SR/CR A1A PEDESTRIAN SAFETY & MOBILITY STUDY

PEDESTRIAN / BICYCLE SAFETY REVIEW

Focus Area I / 19th Road to Apache Drive (Flagler County)

May 2017

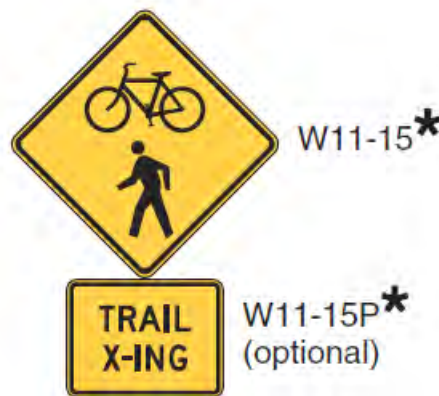
The shared-use path from 16th Road north to Apache Drive has inconsistent signage/markings at the crossing locations with driveways and stop-controlled minor streets. In some locations, just a stop bar is present, whereas in other locations only a stop sign is present. Specific locations with inconsistent signs and/or markings are as follows:

- 16th Road (**Figure 8**);
- Driveways at the Adult & Community Education Center (**Figure 9**);
- Malacompra Road (**Figure 10**); and
- Apache Drive (**Figure 11**).

According to Florida Statute 316.130(7), motorists are required to stop or yield to pedestrians in crosswalks, which would include trail crossings. As stated in the American Association of State Highway and Transportation Officials' (AASHTO) Guide for the Development of Bicycle Facilities, 4th Edition,

“attempts to require bicyclists to yield or stop at each cross street driveway are inappropriate and typically not effective” (p. 5-8). The Guide also notes, “Installing unwarranted or unrealistically restrictive controls on path approaches in an attempt to ‘protect’ path users can result in path users disregarding the signs and other traffic control devices at the intersection. This can lead to a loss of respect for traffic control at more critical locations” (p. 5-34).

As a maintenance-type improvement, consider dispatching a maintenance crew to replace the stop signs/bars with yield signs/markings at unsignalized intersections and driveways (where appropriate). The yield signs/markings will help inform bicyclists they are approaching an intersection and should be cautious of vehicles turning to/from the minor street that may not see them.

In addition to the yield signage/markings for the trail, consider installing trail crossing warning signs (W11-15) and plaques (W11-15P) that would draw the motorist’s attention to the presence of pedestrians or bicycles on the shared use path.

Figure 35

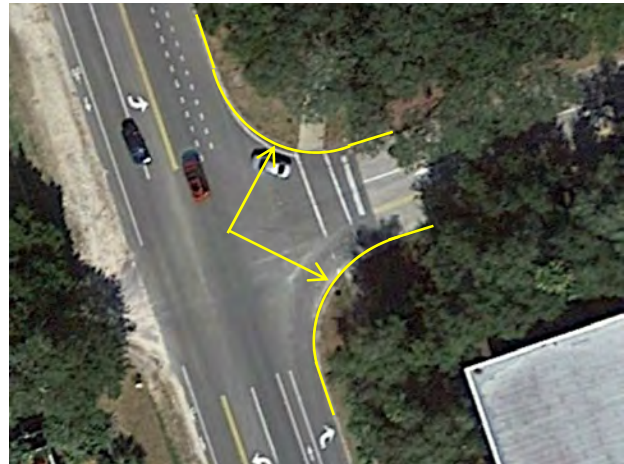
The northeast and southeast corners at 16th Road (**Figure 35**) have large curb return radii (**Figure 36**), which enables drivers to make northbound and westbound right turn movements at higher rates of speed. Vehicles that are traveling faster may not see pedestrians/bicyclists utilizing the crosswalk, thus creating a conflict.

As a near-term improvement, consider reconstructing the northeast and southeast corner curb return radius based on FDOT Standard Index 515 so the driveway throat width is reduced.
